Name	QST95-2000CUT	Secrecy class	
Material	-	1102 K/-	
-	-	CAD Pro/E

Atlas Copco	Scale	5:12	Format	A3	Family	MK2_G	Compare	—	Drawing owner	TOO
	Drawn	B Nilsson		Blank	—	Replaces	—			
Transferred from	Cons.class	1295 K/-	Rev	5	Status	Released	Designation		Sheet 1 (1)	
	Mass/Volume	35.8 kg		Date	2008-10-07		9831 4082 31			
—

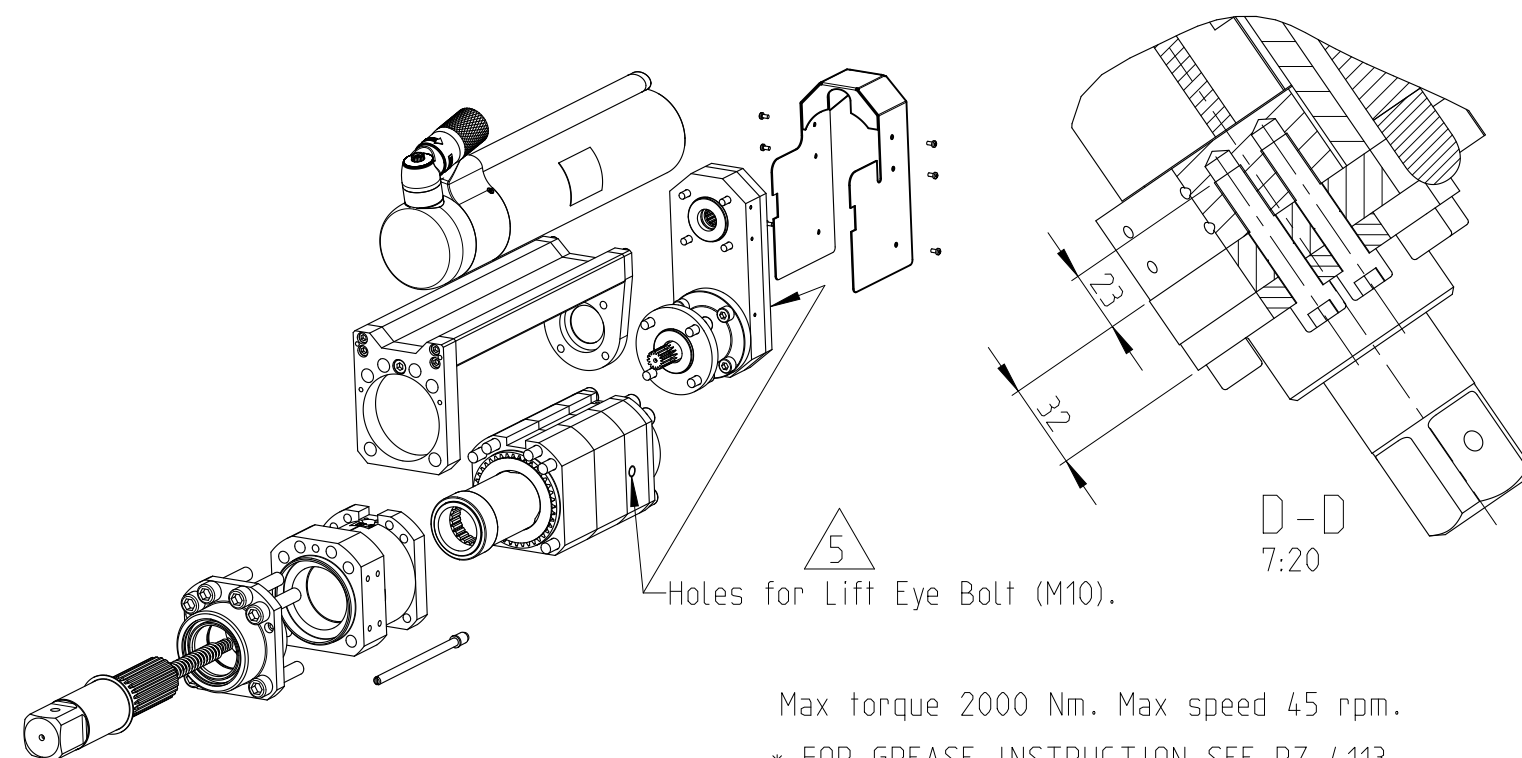
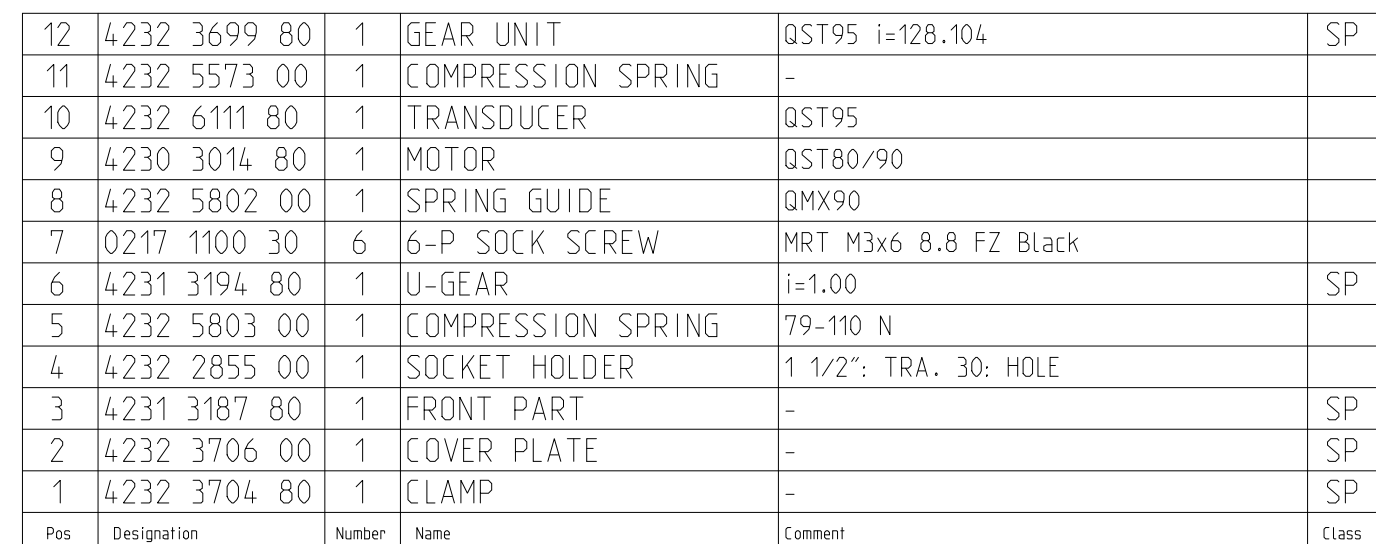
5	B8 F3	Screw 4x 0211 1102 00 replaced with 6x 0217 1100 30. Lift Eye holes added.	2024-09-17	HPN
Note	Pos.	Modified from	Date	Intr.
